**CITY OF SCHERTZ, TEXAS  
WATERLINE RELOCATION: FM 1518 AND WOMAN HOLLERING CREEK  
PROJECT NO. 1124.8410**

**ADDENDUM NO. 1**

**Date of Addendum: September 6, 2012**

**SHEET 3 OF 8 - ADDENDUM 1**  
**WATER LINE RELOCATE**  
**FM 1518 AT WOMAN HOLLERING CREEK**  
**OVERALL PROJECT LAYOUT**

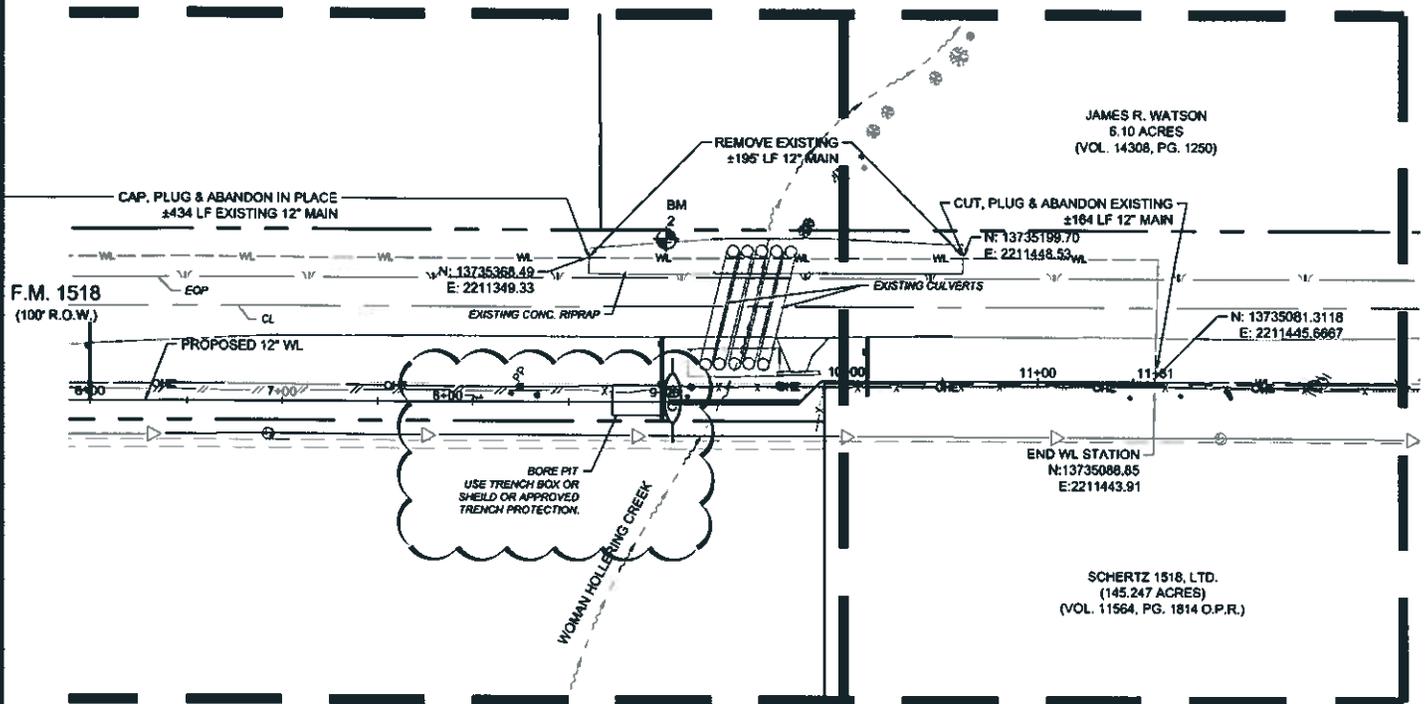
Sheet 3 of 8: Clarification on TPDES requirements, see attached pages 1A and 1B.

- THE CONTRACTOR SHALL BE RESPONSIBLE FOR THE PREPARATION AND IMPLEMENTATION OF THE STORMWATER POLLUTION PREVENTION PLAN, INCLUDING COMPLYING WITH ALL APPLICABLE REGULATIONS RELATED TO NPDES & TPDES, AND SUBMITTING REQUIRED NOTIFICATION OF INTENT AND TERMINATION. THIS IS TO BE PAID FOR UNDER "STORM WATER POLLUTION PREVENTION PLAN" ITEM.

- THE CONTRACTOR SHALL BE RESPONSIBLE FOR THE SITE CONDITIONS DURING CONSTRUCTION AND UNTIL THE PROJECT IS ACCEPTED. THE CONTRACTOR SHALL BE RESPONSIBLE FOR OBTAINING THE STORM WATER POLLUTION PREVENTION PLAN, UNDERSTAND THE REQUIREMENTS FOR THE PLAN, AND SHALL BE RESPONSIBLE FOR IMPLEMENTING THE PLAN. THIS IS TO BE INCLUDED UNDER SECTION 01410 "STORM WATER POLLUTION PREVENTION PLAN". ALL FINES IMPOSED FOR NOT IMPLEMENTING OR MAINTAINING SWPPP MEASURES SHALL BE THE RESPONSIBILITY OF THE CONTRACTOR.

- PLACE SILT FENCE EVERY 300 FT FOR WIDTH OF DISTURBED AREA, AT A MINIMUM.
- DISTURBED AREAS TO BE REVEGETATED WITH BERMUDA SOD OR NATIVE GRASS AS PART OF SITE RESTORATION ITEM.

- BORE PITS TO BE RESTORED PER SCHERTZ STANDARD SPEC 02317 "EXCAVATION AND BACKFILL FOR UTILITIES", MINIMUM COMPACTION OF 90% ASTM D 698.
